# **service bulletin**

**Bulletin No. 2003-01**

## **Required MCM and MIE Water Inlet Hose Replacement**

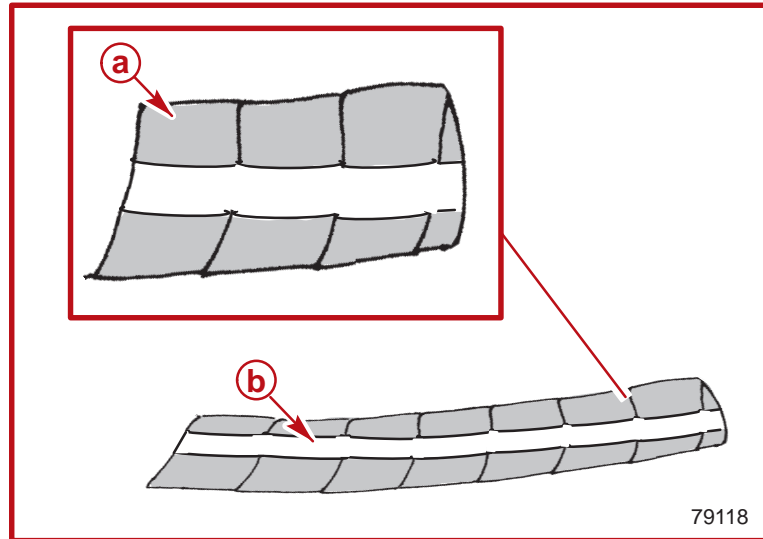
The walls of the water inlet hose(s) used on the engines listed above are thinner than required and can collapse during engine operation.

Only certain water inlet hoses on the engine are affected. Refer to the drawing to identify the inlet hoses that need to be changed. A wrapped hose with a stripe (white or blue) along its length needs to be replaced. If the hose does not have a stripe on it, it does not need to be replaced. The suspect hose locations are listed below.

- a** - Hose with 'Wrapped' Outer Surface.
- b** - Stripe Along Length (White or Blue Color).

Order 1 qty      P/N 32-863343 65      Water Hose, 96.5 cm (38 in.) long.

1. MCM 4.3L, 5.0L, 5.7L, 350 and MX6.2 Bravo Sterndrive engines: Use hose as is.
2. MCM 496 Mag Sterndrive engines: Cut a 59.7 cm (23-1/2 in.) long hose and a 25.4 cm (10 in.) long hose from this hose. Use in locations described previously.
3. MIE 8.1S Inboard engines: Cut 25.4 cm (10 in.) long hose and use at location described previously.
